Atty. Docket No. PIA31222/DBE/US
Serial No: 10/751,199

Amendments to the Drawings

REMARKS/ARGUMENTS

FIG. 1

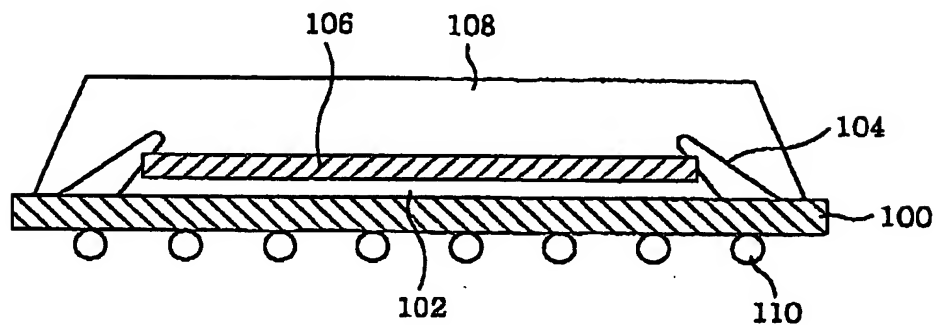
The attached sheet of drawings includes changes to Fig. 1. This sheet, which includes Figs. 1-2, replaces the original sheet including Figs. 1-2. In Fig. 1, the legend "Prior Art" is added as required by the Examiner.

Fig. 1 has been amended to overcome the Examiner's objection to the drawings without adding any new matter and in full compliance with statutory and regulatory requirements.

(PRIOR ART) — added
